TECHNICAL BULLETIN EN - 28 (REV. A)

MODEL YEAR: 1986 ~ 2002 (EXCEPT 1992 ~ 1994) **ENGINE MODEL:** FE6T/FE6TA 12-VALVE/FE6TA 24-VALVE

FE6 ENGINE SIDE COVER CHANGE

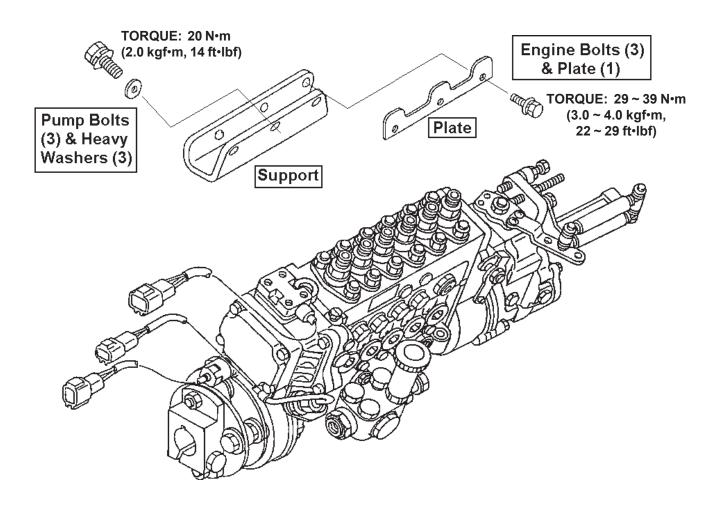
Three new bolts for the support-to-injection pump and three new bolts for the support-to-engine are included with the conditional parts. Also included is a flat plate and three heavy flat washers.

When installing the injection pump support bracket between the engine and injection pump, install the flat plate beneath the head of the three support-to-engine bolts, and the heavy flat washers beneath the head of the three support-to-injection pump bolts.
